Applicant/Serial No.: Haruhiro Watanabe / 10/624,168
Filed/Conf. No. 07/21/2003 / Conf. No. 6365
Examiner/Group: Michael S. Lowe / 3652
Amendment mailed: 12 / 08 / 2005
Attorney File: MM0721US (#90326)

REMARKS

AMENDMENTS TO THE DRAWINGS

FIG. 12 (d)

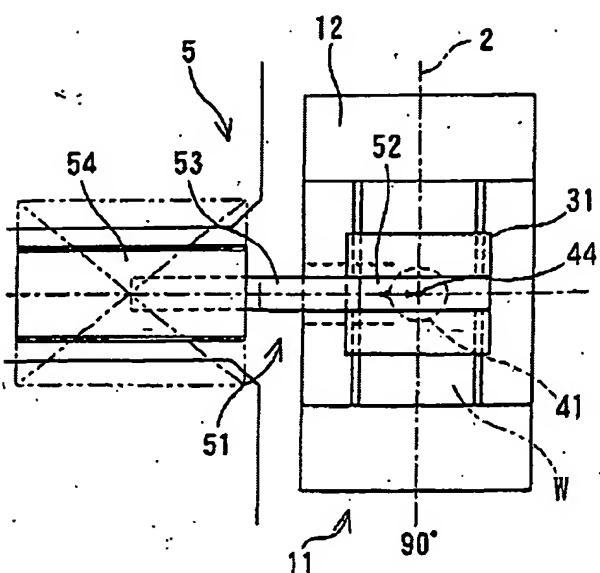
Turning first to the drawings, new Figs. 10(d) and 12(b) have been added, and the Annotated Sheets showing Changes with new figures are attached. Replacement Sheets in draft form are also attached, but they will be replaced once approved by the Examiner.

These figures show the transfer of an article W supported by upper fork member 54 to the article unloading section 5 following the step shown in Fig. 10(c) pursuant to the first embodiment of the invention. Likewise, in accordance with the second embodiment of the invention, Fig. 12(d) follows the action subsequent to that of Fig. 12(c), and upper fork member 54 has been moved to article loading section 5. The specification has been amended accordingly, since paragraphs [0056] and [0064] have been amended to reflect that the details set forth in those paragraphs are shown in the drawings. It is requested that the objection to the drawings be withdrawn. It is furthermore requested that the Examiner advise the undersigned if the drawings are in an acceptable form, after which formal drawings will be filed for the above-identified application.

Drawing figure sheets showing original Figs. 10(a)-10(c) with a new Fig. 10(d) and original Fig. 12(a)-12(c) with a new Fig. 12(d) are attached labeled as "Annotated Sheet Showing Changes" and "Replacement Sheet." These are both in draft form. Once approved, a formal set of both drawing figure sheets marked "Replacement Sheet" will be filed.
